Subject: UniStar Nuclear Energy, NRC Docket No. 52-016
Response to Request for Additional Information for the
Calvert Cliffs Nuclear Power Plant, Unit 3,
RAI 218 and RAI 229, Stability of Subsurface Materials and Foundations

Response to NRC Request for Additional Information

**RAI 218 Questions 02.05.04-03, 02.05.04-09, 2.05.04-10 and 2.05.04-15
and**

RAI 229 Questions 02.05.04-17 and 02.05.04-19,

Zones Selected for the Assessment of Soil Parameter Variability

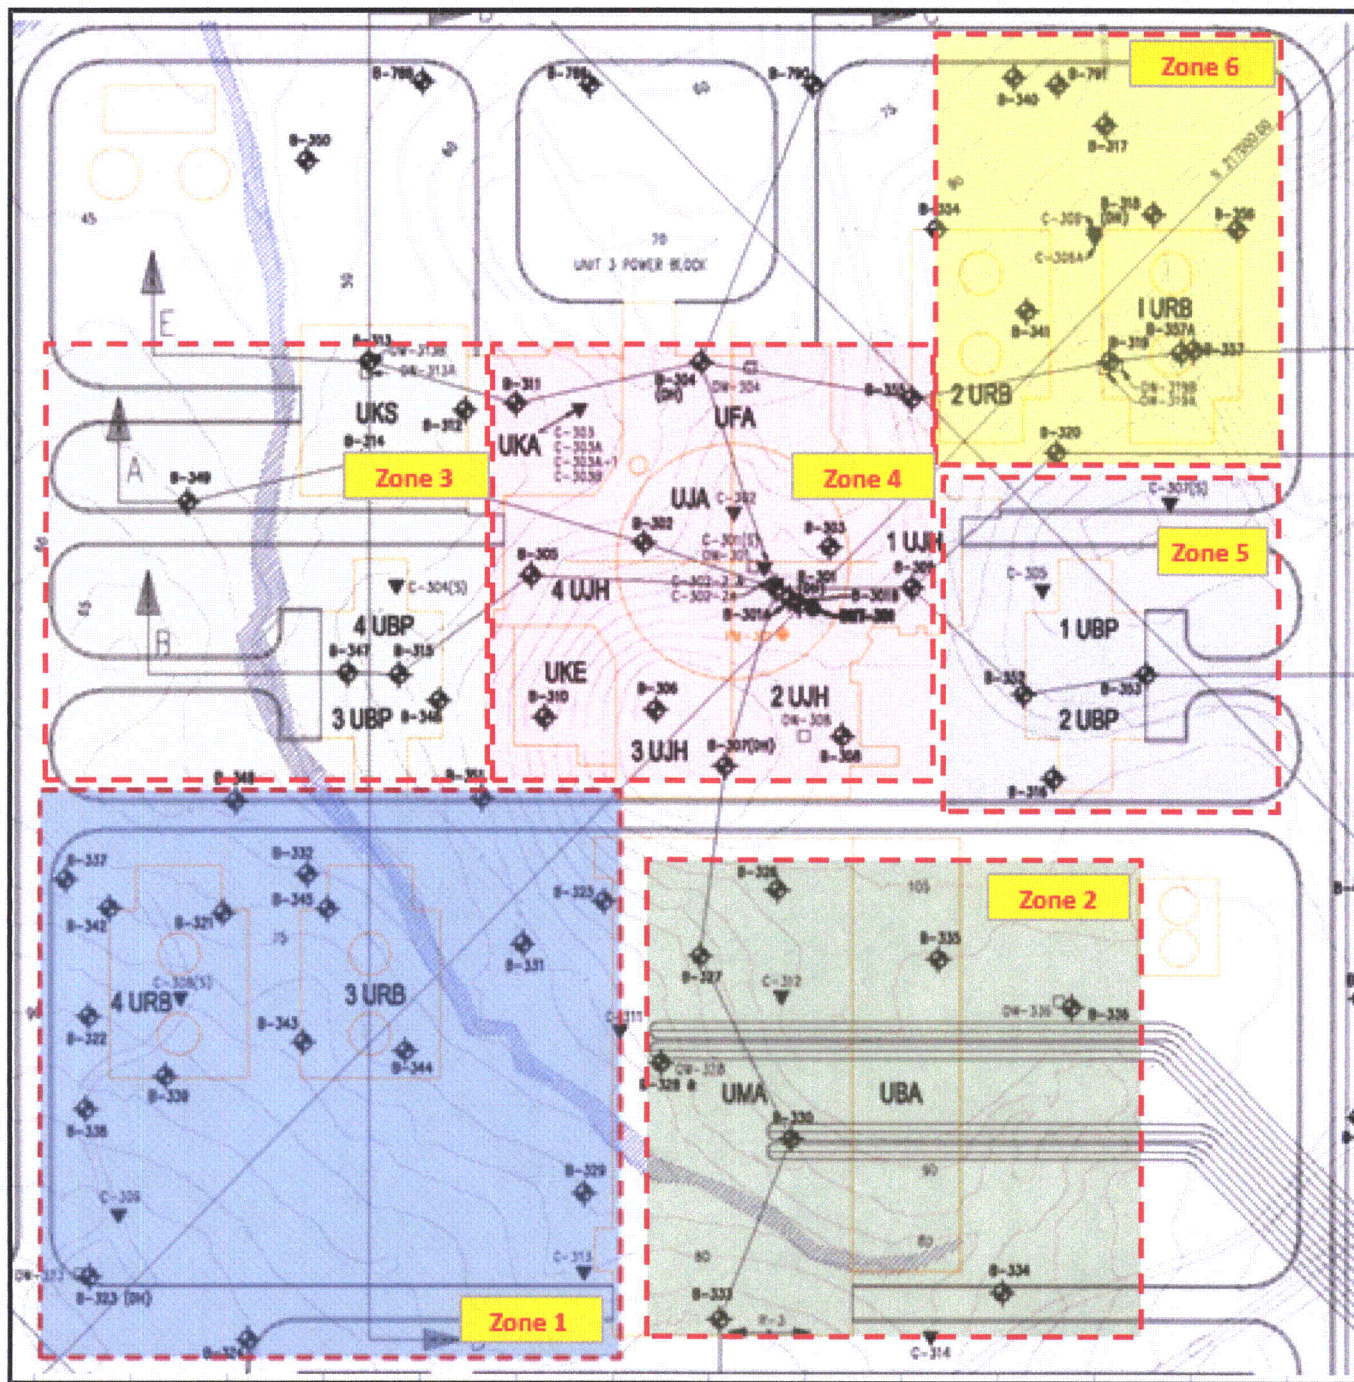
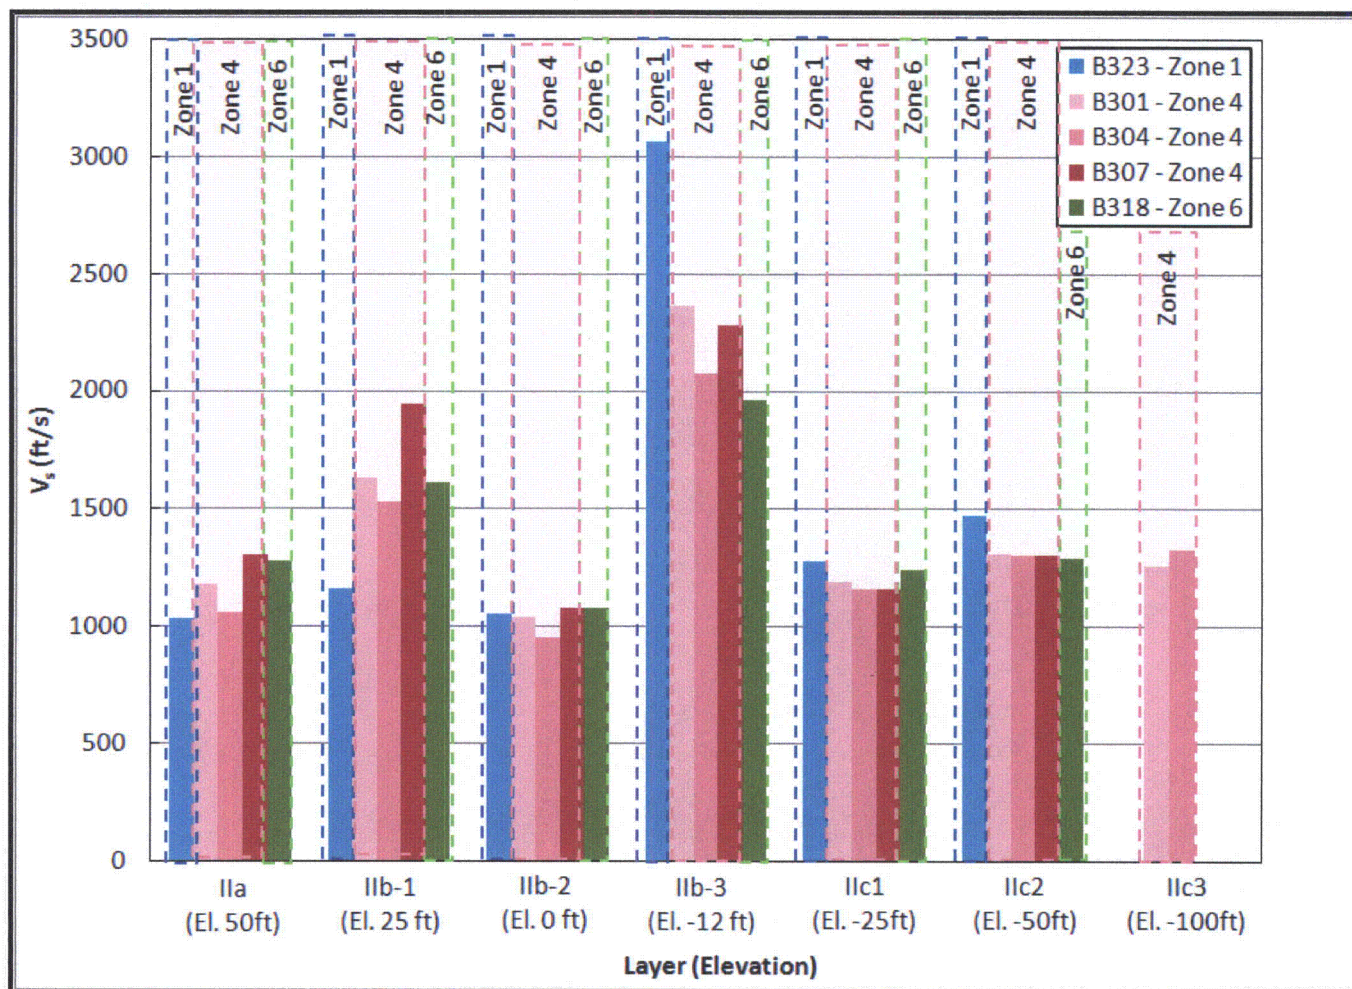
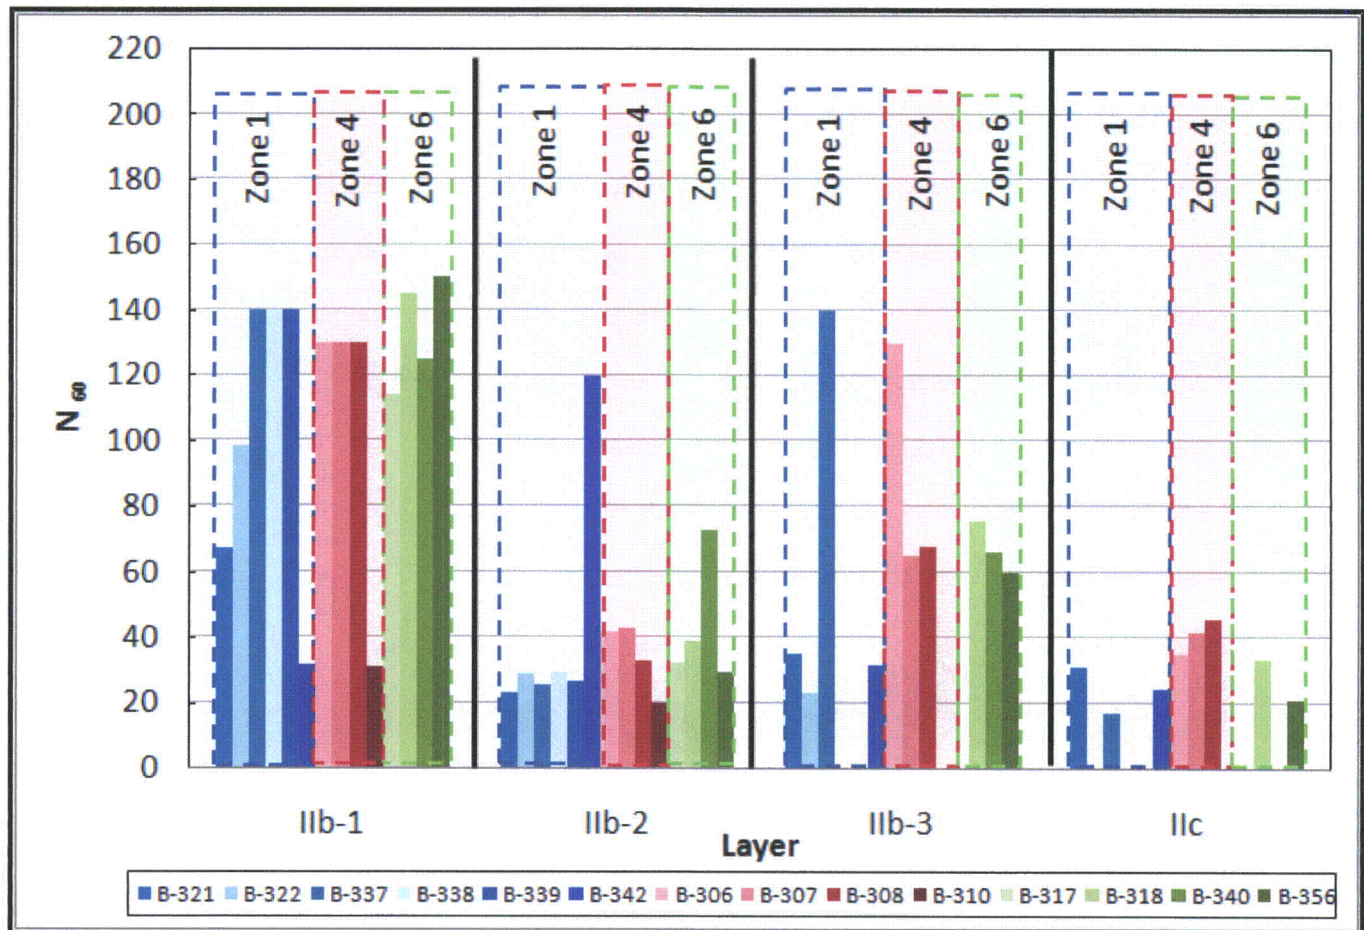
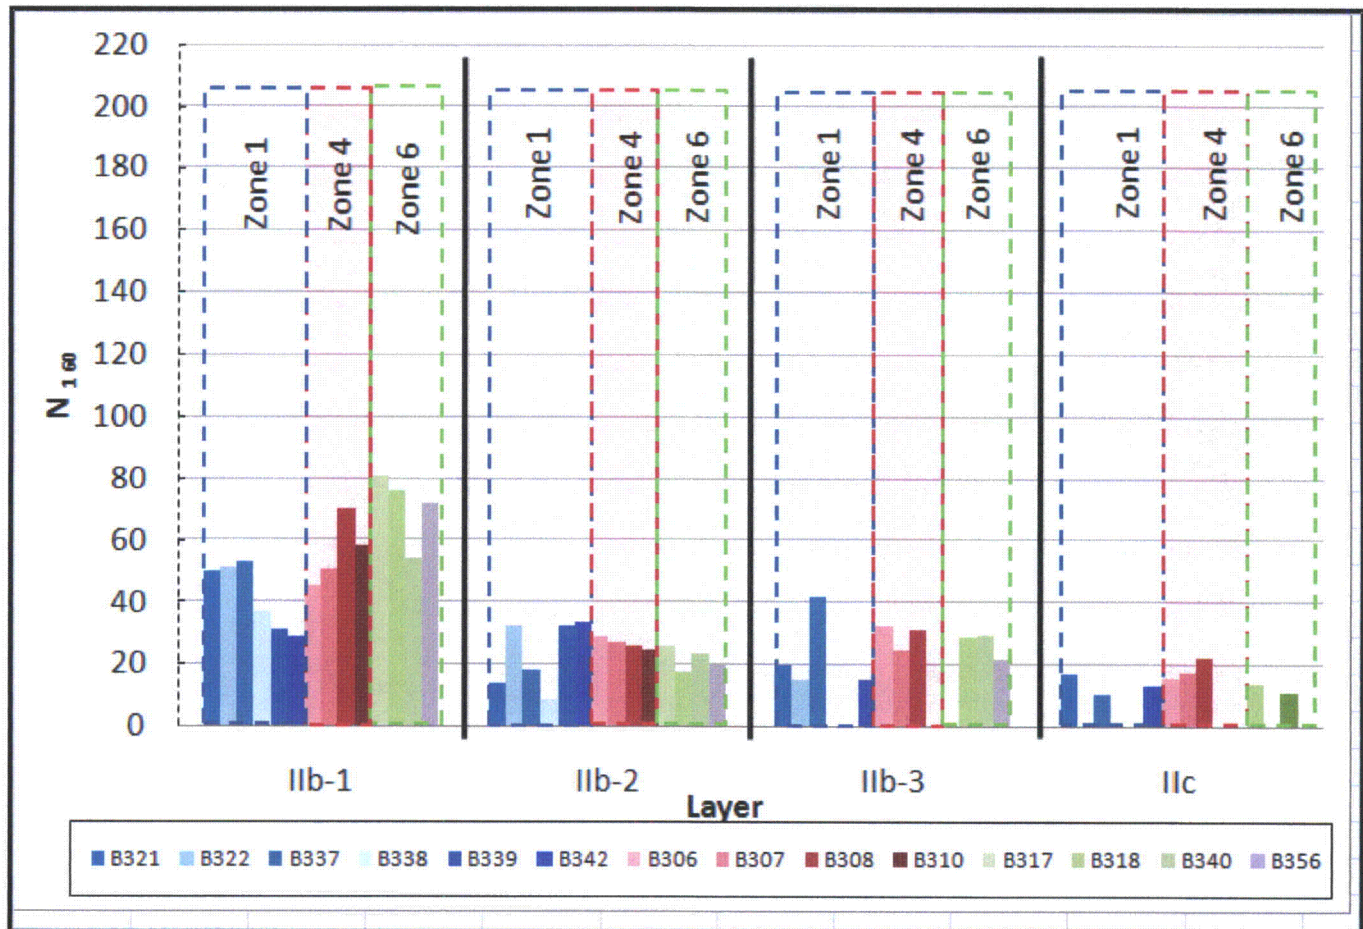
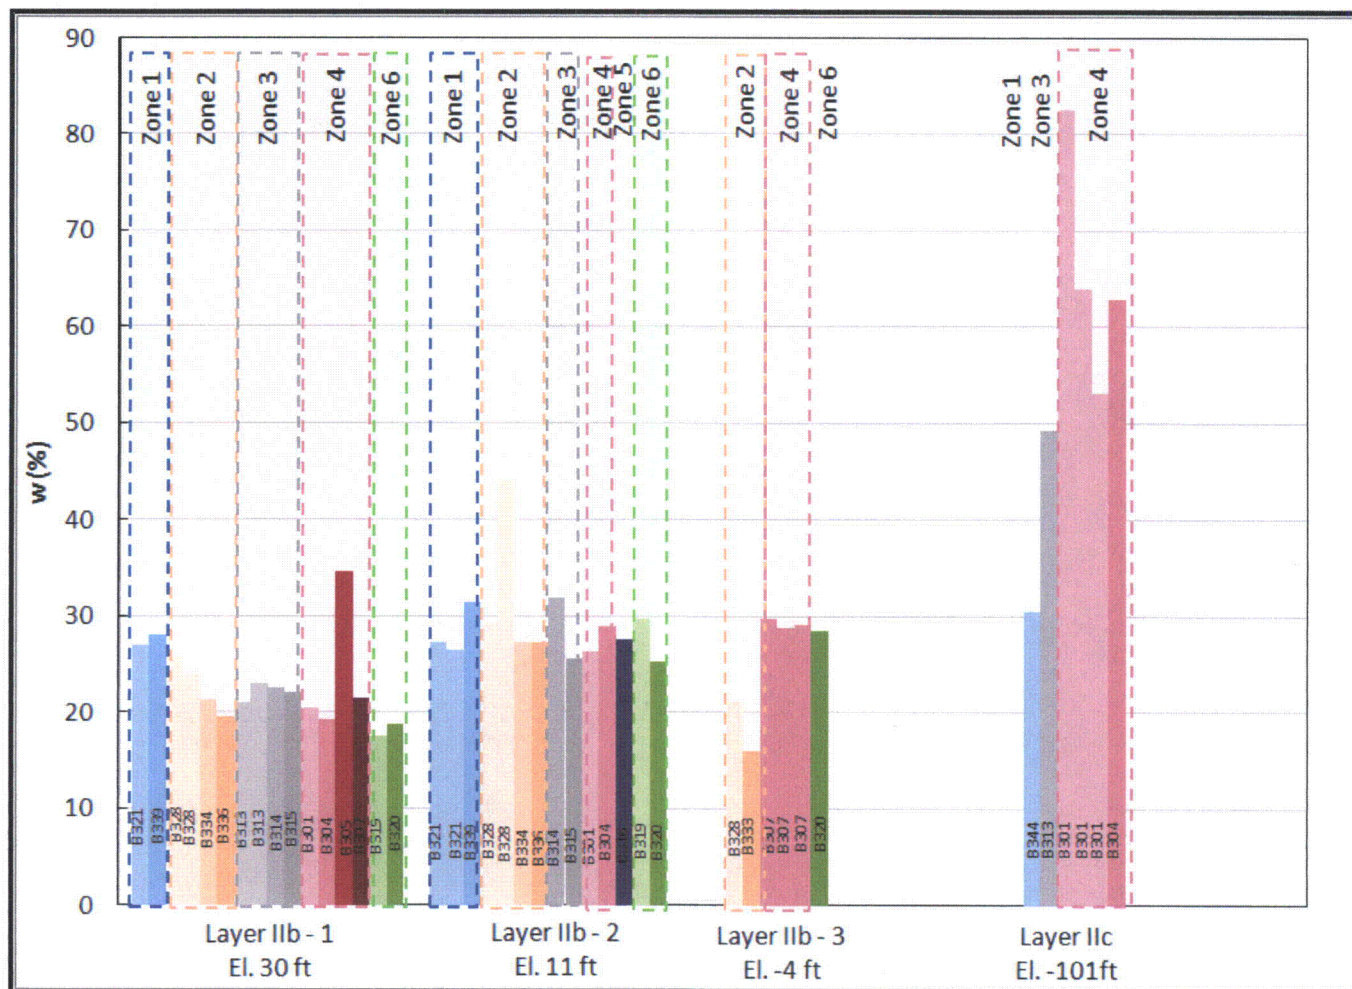
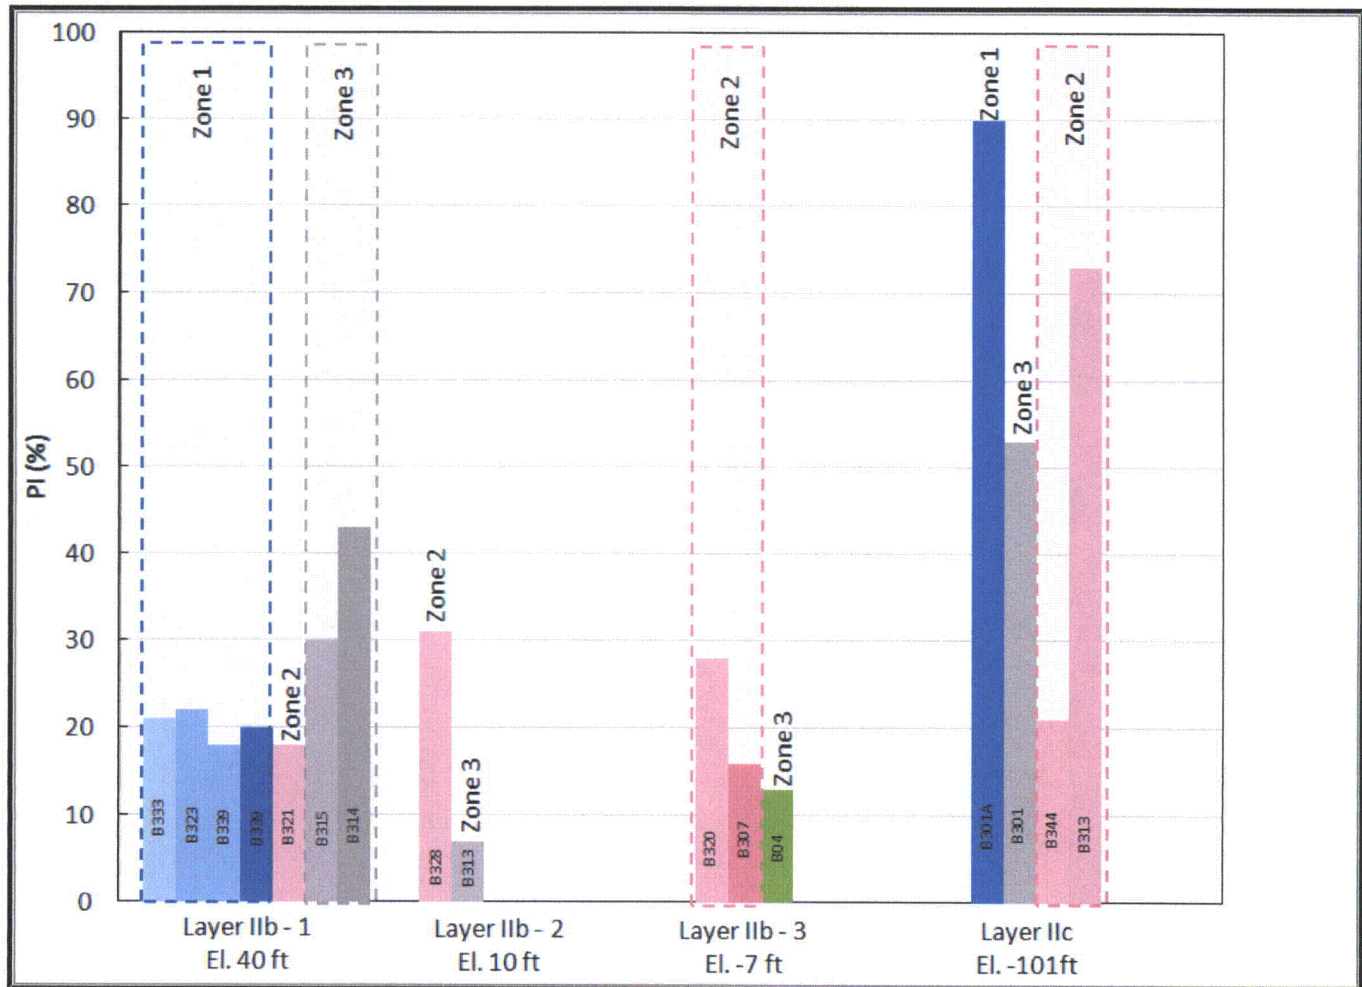
1. Please explain the adequacy of the initial stress conditions selected in your FEM settlement calculation.
2. Please evaluate the possibility of any additional settlement caused by seismic event at the site.
3. Please address the effects of soil parameter variation and spatial variability on your settlement analysis.
4. Please address differential settlement between the nuclear island and adjacent structures, and compliance with the U.S. EPR standard design.
5. Please justify the assumptions, especially the determination of stress increases in each layer, used in the hand calculation of settlement you performed.

The site was divided into six zones, Zone 1 to Zone 6 (Figure 16). The measurements in each zone were compiled and the change in each soil parameter was compared with the measurements from other zones. The results from the zones that are distant from each other (e.g., Zone 1 and Zone 6) provide the level of soil parameter variability throughout the power block area.

For all layers, except for Stratum IIb-3, Figure 17 indicates that the variation within Zone 4 is almost the same as the variation between Zone 1, Zone 4, and Zone 6. This implies that the shear wave velocity is independent of horizontal location. For Stratum IIb-3, the shear wave velocity is high in Zone 1 according to data from boring B323. However, this is based on only one data point that could be spurious.

Figure 18 shows the variation of SPT blow counts corrected for energy efficiency N_{60} for different borings at given elevations. The analysis was conducted at mid-elevations of Layers IIb-1, IIb-2, IIb-3, and IIc. According to Figure 18, N_{60} is highly variable at a given elevation for all layers. Furthermore, no distinct correlation between zone number and N_{60} can be deduced from Figure 18. Specifically, for layer IIb-3, the change in shear wave velocity (high in Zone 1 lower in Zone 6) contradicts with change in N_{60} (low in Zone 1 and higher in Zone 6). This comparison excludes the outliers. As a conclusion, the scatter in N_{60} cannot be explained using the horizontal location in the power block area. Alternative explanation for the scatter within each zone and all zones in general may be the inherent scatter (aleatory uncertainty) involved in SPT testing procedure, and fluctuations in overburden stress, and groundwater elevation. The effect of overburden stress and groundwater elevation can be considered by looking at stress corrected blow counts as $(N_1)_{60}$. Figure 19 shows the $(N_1)_{60}$ variation for borings considered in Figure 18. $(N_1)_{60}$ distribution is more uniform at a given elevation

compared to N_{60} distribution since the scatter due to overburden stress and groundwater elevation is implicitly reduced by $(N_1)_{60}$ evaluation. The scatter observed in Figure 19 for a given layer at a given elevation is attributed to the inherent scatter involved in SPT testing procedure on site. Again, the scatter does not seem to be a function of the zone number.

Soil index properties such as water content and plasticity index (PI) distribution impact the measured shear wave velocity and N_{60} . The water content and PI for different layers at a given elevation (tolerance is ± 3 ft) and zones are given in Figures 20 and 21, respectively. For Strata IIb-1, IIb-2, and IIb-3, the scatter in water content for a given zone can be as large as the overall scatter when all zones are considered. For Stratum IIb-1, Zone 1 has slightly higher water content than Zones 2, 3, 4 and 6. The value of water content for Zone 5 is relatively different when compared with other zones for Stratum IIb-1. For Stratum IIb-3, Zone 4 has slightly larger water content than Zone 2. Scatter in PI shown in Figure 21 is large and random.
